SERVICE BULLETIN

NUMBER: 12-288-20R

SUBJECT: Power Front Seat Cushion Frame / Slide Rail- Design Change

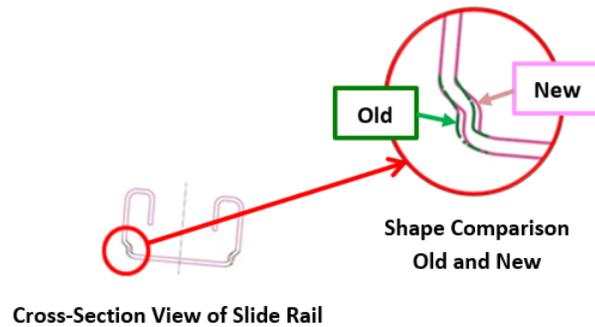
- This illustration shows the design change made to the shape of the Slide Rail.

- Confirm the replacement seat frame assembly contains the new Slide Rails. The part table below lists the part numbers that have the design change incorporated.
